## DSA CODE AMENDMENT DEVELOPMENT

Tracking	
Date Received:	-
DSA Tracking Number:	N/A
Date Reviewed:	8/30/19
Status:	Under consideration

Applicable Code
Applicable Code Section(s): CBC Ch. 1, Scope and Administration
Topic: Public housing

**Figure 11B-604.3.2 (Exception)**  
Overlap of Water Closet Clearance in Residential Dwelling Units

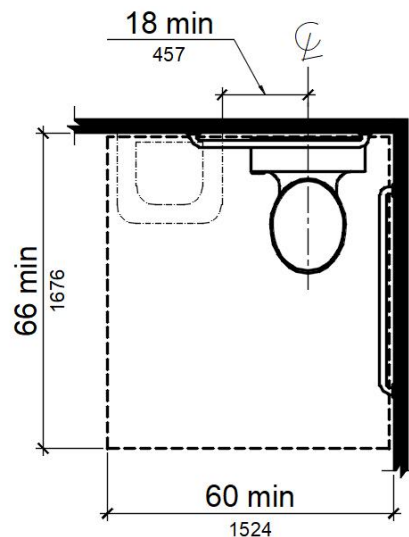
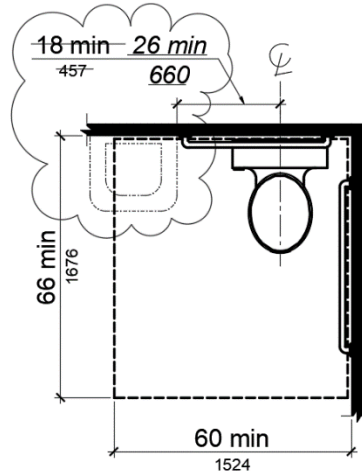
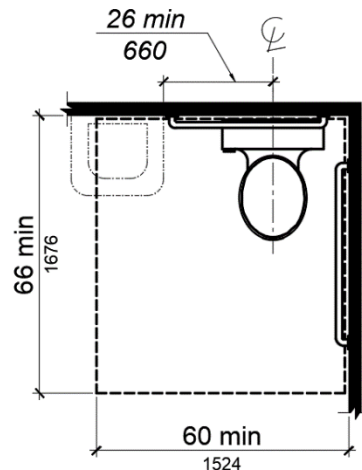
**Exception:** In residential dwelling units, a lavatory complying with *Section 11B-606* shall be permitted on the rear wall 18 inches (457 mm) 26 inches (660 mm) minimum from the water closet centerline where the clearance at the water closet is 66 inches (1676 mm) minimum measured perpendicular from the rear wall.

**Exception:** In residential dwelling units, a lavatory complying with *Section 11B-606* shall be permitted on the rear wall 26 inches (660 mm) minimum from the water closet centerline where the clearance at the water closet is 66 inches (1676 mm) minimum measured perpendicular from the rear wall.

**FIGURE 11B-604.8.1.2  
MANEUVERING SPACE WITH SIDE-OPENING DOOR**

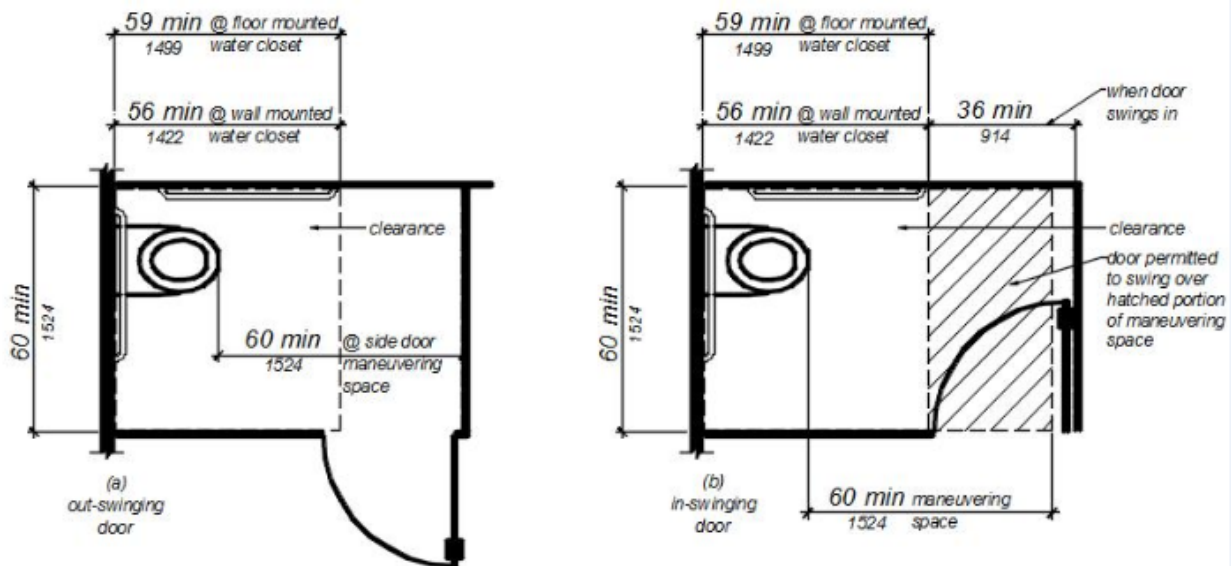
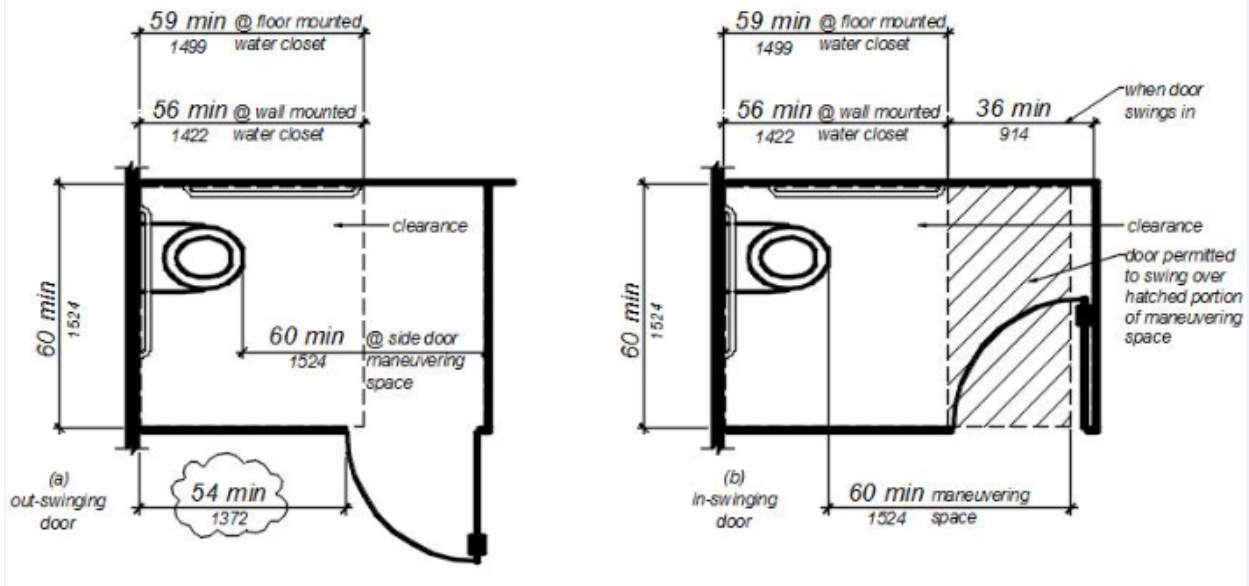
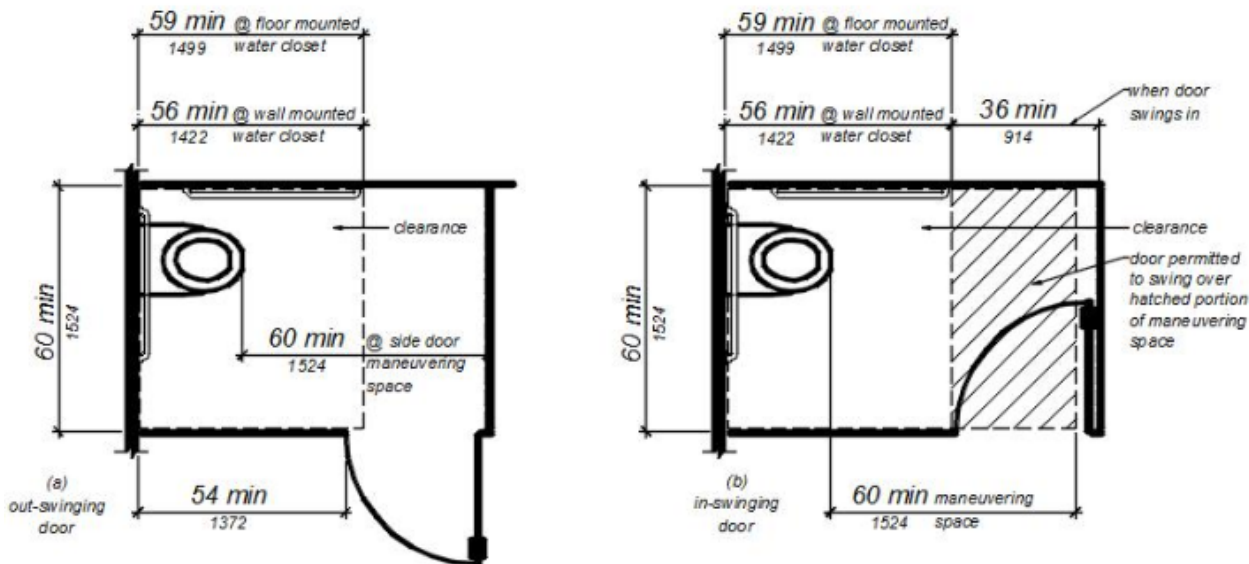
**11B-604.8.1.2 Doors.** Toilet compartment doors... Doors shall be located in the front partition or in the side wall or partition farthest from the water closet. Where located in the front partition, the door opening shall be 4 inches (102 mm) maximum from the side wall or partition farthest from the water closet. Where located in the side wall or partition, ~~the door opening shall be 4 inches (102 mm) maximum from the front partition~~ the door opening shall be farthest from the water closet and shall be 54 inches (1372 mm) minimum from the rear wall...

DSA-AC is proposing to amend Section 11B-604.8.1.2 and Figure 11B-604.8.1.2 to revise the required location for out-swinging toilet compartment doors in the side wall or partition of an accessible toilet compartment. The current provisions require the door to be 4 inches maximum from the front partition. This proposal allows the toilet compartment door to be located in a variety of locations in the side wall or partition while maintaining equal or greater accessibility than the current CBC Chapter 11B requirements and the 2010 ADA Standards for Accessible design.

**11B-604.8.1.2 Doors.** Toilet compartment doors... Doors shall be located in the front partition or in the side wall or partition farthest from the water closet. Where located in the front partition, the door opening shall be 4 inches (102 mm) maximum from the side wall or partition farthest from the water closet. Where located in the side wall or partition, *the door opening shall be farthest from the water closet and shall be 54 inches (1372 mm) minimum from the rear wall...*

**Figure 11B-608.5.2**  
**Standard Roll-In Type Shower Compartment Control Location**

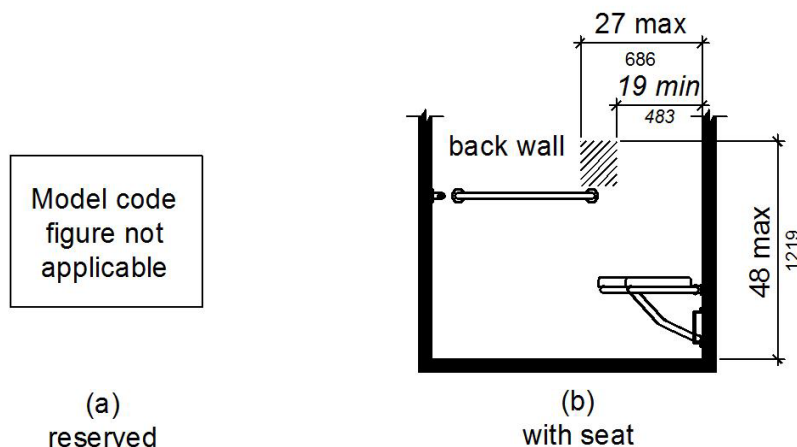
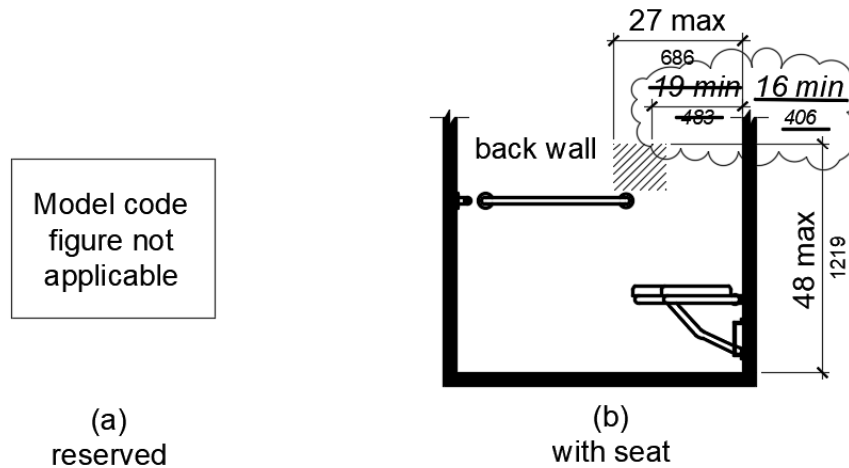
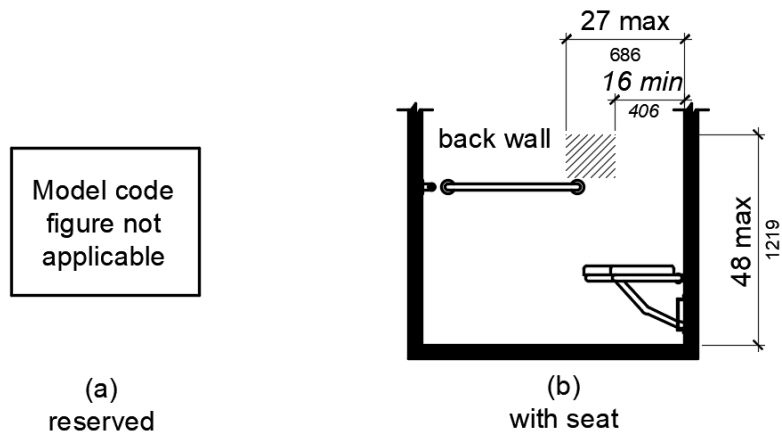
**11B-608.5.2 Standard roll-in type shower compartments.** In standard roll-in type shower compartments, ~~operable parts of controls and faucets shall be installed on the controls, faucets, and the shower spray unit shall be located on the back wall of the compartment adjacent to the seat wall 19 inches (483 mm) minimum and 16 inches (406 mm) minimum and 27 inches (686 mm) maximum from the seat wall; and shall be located above the grab bar, but no higher than 48 inches (1219 mm) above the shower floor, with their centerline at 39 inches (991 mm) to 41 inches (1041 mm) above the shower floor.~~

~~Operable parts of the shower spray unit, including the handle, shall be installed on the back wall adjacent to the seat wall 19 inches (483 mm) minimum and 27 inches (686 mm) maximum from the seat wall; and shall be located above the grab bar, but no higher than 48 inches (1219 mm) above the shower floor.~~

**11B-608.5.2 Standard roll-in type shower compartments.** In standard roll-in type shower compartments, the controls, faucets, and the shower spray unit shall be located on *the back wall of the compartment adjacent to the seat wall 16 inches (406 mm) minimum and 27 inches (686 mm) maximum from the seat wall; and shall be located above the grab bar, but no higher than 48 inches (1219 mm) above the shower floor.*

**Figure 11B-608.5.3**  
**Alternate Roll-In Type Shower Compartment Control Location**

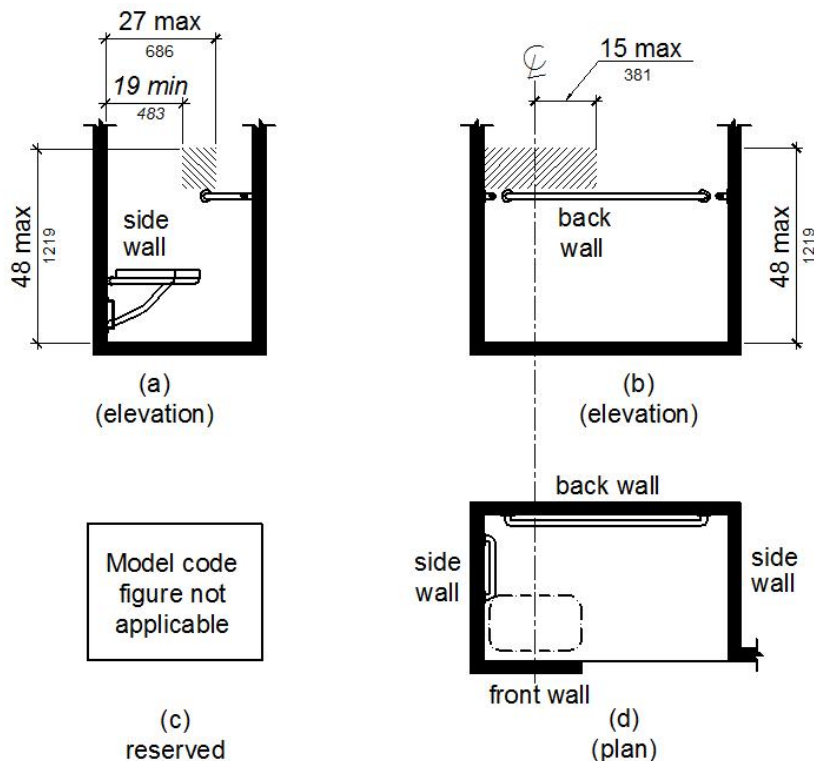
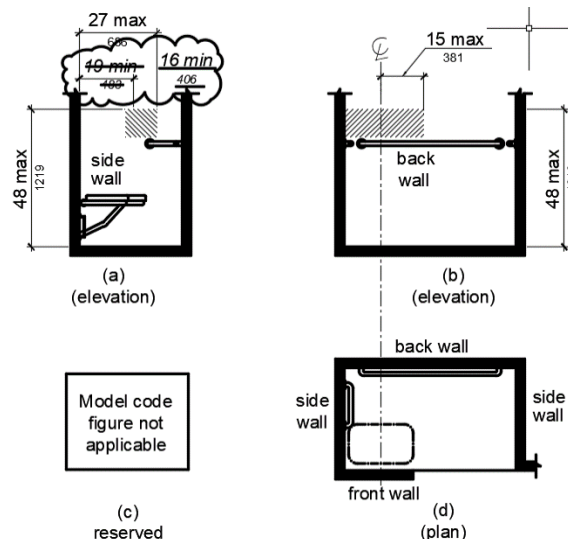
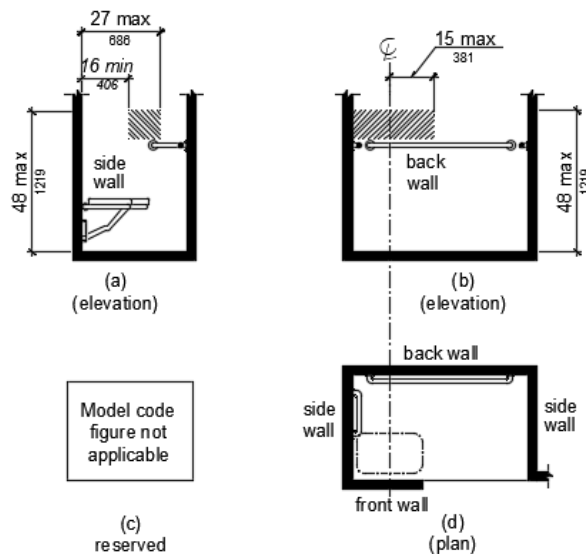
**11B-608.5.3 Alternate roll-in type shower compartments.** *In alternate roll-in type shower compartments, ~~operable parts of controls and faucets shall be installed~~ the controls, faucets, and shower spray unit shall be located on the side wall of the compartment adjacent to the seat wall 19 inches (483 mm) minimum and 16 inches (406 mm) minimum and 27 inches (686 mm) maximum from the seat wall; or shall be located on the back wall opposite the seat 15 inches (381 mm) maximum, left or right of the centerline of the seat. and ~~The operable parts of~~ controls, faucets, and shower spray units shall be located above the grab bar, but no higher than 48 inches (1219 mm) above the shower floor, with their centerline at 39 inches (991 mm) to 41 inches (1041 mm) above the shower floor. Operable parts of the shower spray unit, including the handle, shall be installed on the side wall of the compartment adjacent to the seat wall 17 inches (432 mm) minimum and 19 inches (483 mm) maximum from the seat wall or on the back wall opposite the seat 15 inches (381 mm) maximum, left or right, of the centerline of the seat; and shall be located above the grab bar, but no higher than 48 inches (1219 mm) above the shower floor.*

**11B-608.5.3 Alternate roll-in type shower compartments.** In alternate roll-in type shower compartments, the controls, faucets, and shower spray unit shall be located *on the side wall of the compartment adjacent to the seat 16 inches (406 mm) minimum and 27 inches (686 mm) maximum from the seat wall* or shall be located on the back wall opposite the seat 15 inches (381 mm) maximum, left or right of the centerline of the seat. The controls, faucets, and shower spray units shall be located above the grab bar, but no higher than 48 inches (1219 mm) above the shower floor.
